City of Parramatta	
File No:	DA/900/2022

SECTION 4.15 ASSESSMENT REPORT
Environmental Planning & Assessment Act 1979

DA No:	DA/900/2022
Subject Property:	LOT 5 DP 205980, 32 Honiton Avenue, CARLINGFORD NSW 2118
Proposal:	Demolition, tree removal and construction of a centre-based child care facility to accommodate 67 children with ground and basement level parking for 17 cars.
Date of receipt:	15 November 2022
Applicant:	ArtMade Architects
Owner:	Mr A Abi-Khattar
Property owned by a Council employee or Councillor:	The site is not known to be owned by a Council employee or Councillor
Political donations/gifts disclosed:	None disclosed on the application form
Submissions received:	Fifty-three (53) unique submissions, with two (2) petitions comprising of 100 signatures
Conciliation Conference Held:	No
Recommendation:	Refusal
Assessment Officer:	Felicity Lam

Figure 5: Western Elevation (Architectural Plans)

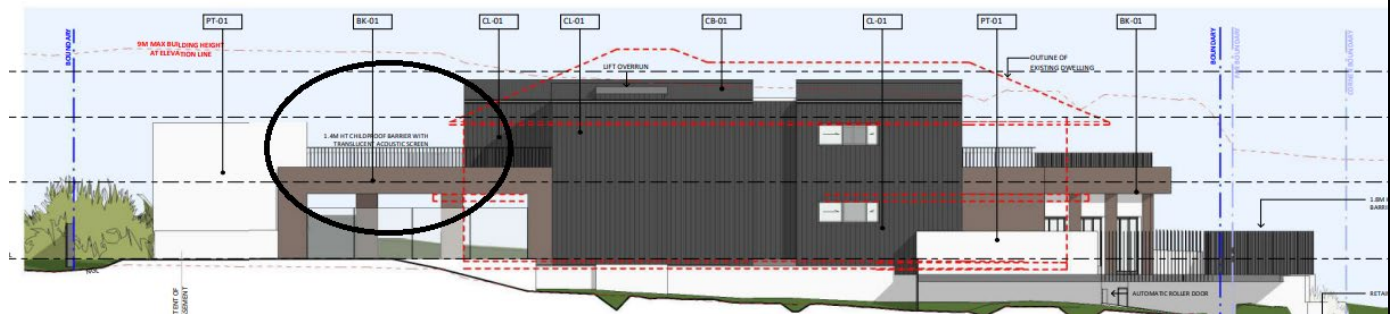
No – There is potential for overlooking to the main living areas and private open spaces of adjacent residential dwellings, specifically 1B Clover Close and 34 Honiton Avenue. As shown in the figure below.
